TECHNICAL BULLETIN — October 2015

400. Hydraulic cylinder problems

Service Bulletin

Action required in relation to attention items as described by Hoerbiger Micro Fluid GmbH.

Figure 3: information for LE32 and LE25 screw connection at the bottom.

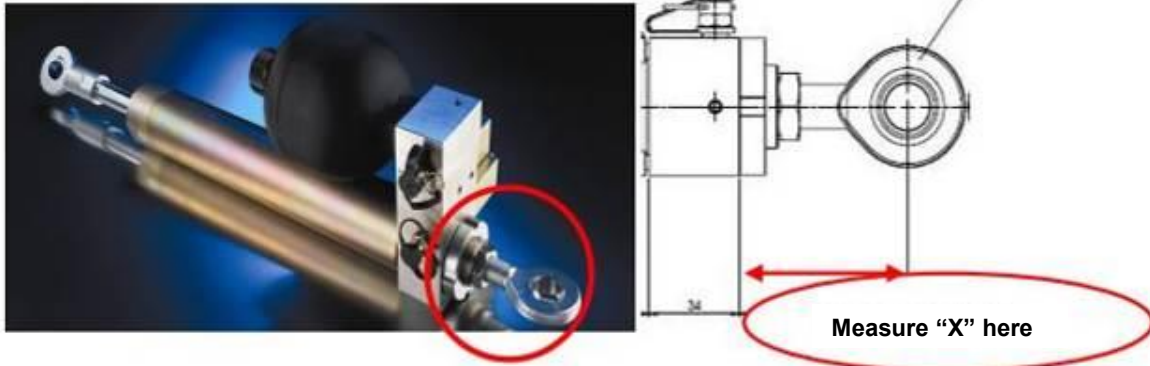
The following data apply for all LE32 versions:

For the LE 32 versions the screw thread depth is correct when the rod end length “X” is below 65 mm. ($X < 65\text{mm}$)

The following data apply for all LE25 versions:

For the LE 25 versions the screw thread depth is correct if the rod end length “X” is below the value as stated behind the product number in de table below. The small x at the end of the product number indicates the version number.

Product number	Maximum screw thread depth “X”	
850-7001-x	68	Mm
850-7002-x	68	Mm
850-7003-x	68	Mm
850-7004-x	68	Mm
850-7010-x	68	Mm
850-7013-x	65.5	Mm
850-7015-x	68	Mm
850-7016-x	68	Mm
850-7018-x	68	Mm
850-7019-x	68	Mm
850-7020-x	63.25	Mm
850-7021-x	63.25	Mm
850-8002-x	66	Mm
850-8003-x	66	Mm
850-8007-x	65.5	Mm
850-8008-x	68.25	Mm
850-8009-x	68.25	Mm

We strongly urge you to immediately check the measurement set out above on all Personal Restraint Systems in your possession and advise your technicians to adjust and maintain the measurements specified when installing the unit into a Personal Restraint System or during routine maintenance.

We recommend that the joint rod heads be secured at the specified dimensions and tightened with a torque wrench. The LE 25 version should be tightened to **80 Nm ±10 Nm**. The LE 32 version should be tightened to **90 Nm ±10 Nm**.

The correct measurement must be set and checked when installing or performing maintenance on the Cylinder Accumulator unit. In this way the required minimum screw thread depth engagement (as set out in VDI 2230) is maintained.

This example image is for reference of dimension X only.

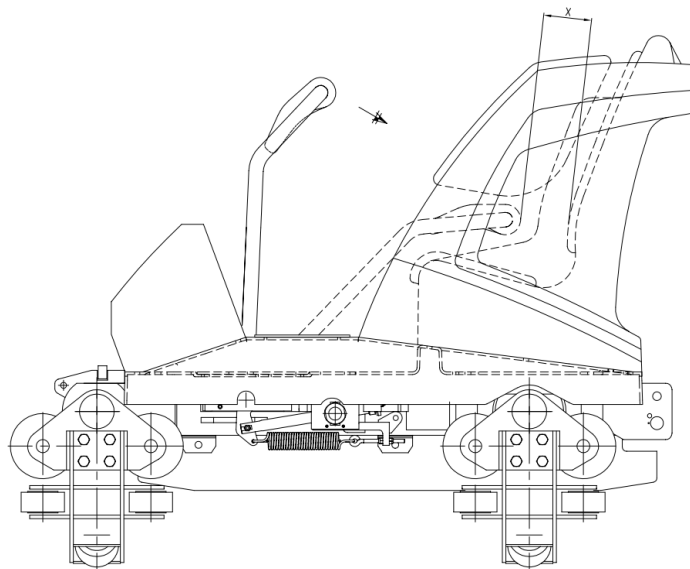
2.5 Cycle testing

The cycle test is a test which provides information about the functionality of the HLU and the scale of the contaminations. The cycles test has to be performed 1050 times. After completion of 200 cycles succesfully, the ride can be taken into operation with passengers.

Test procedure, **restraint with 2 HLU's**;

1. Close the restraint, make sure the right hand side HLU is only locking the restraint;
2. Measure the minimal distance (X) between the restraint and the seat (only at start of test);
3. Log this dimension for every seat (only at start of the test);
4. Wait for 10 seconds;
5. Measure the minimal distance (X) between the restraint and the seat;
6. In case this dimension increased by 2 cm the HLU failed and needs to be replaced immediately by a HLU which passed the 1050 cycles;
7. If no dimension change was noticed proceed with step 1;
8. Keep repeating this procedure until 200 cycles have passed the test procedure;
9. Repeat this test and make sure the left hand side HLU is only locking the restraint;
10. After completion of the 200 cycle test for the left and the right HLU it is allowed to take the vehicle in operation.

Test procedure, **restraint with 1 HLU**;

1. Close the restraint
2. Measure the minimal distance (X) between the restraint and the seat (only at start of test);
3. Log this dimension for every seat (only at start of the test);
4. Wait for 10 seconds;
5. Measure the minimal distance (X) between the restraint and the seat;
6. In case this dimension increased by 2 cm the HLU failed and needs to be replaced immediately by a HLU which passed the 1050 cycles;
7. If no dimension change was noticed proceed with step 1;
8. Keep repeating this procedure until 200 cycles have passed the test procedure;
9. After completion of the 200 cycle test for the single HLU it is allowed to take the vehicle in operation.
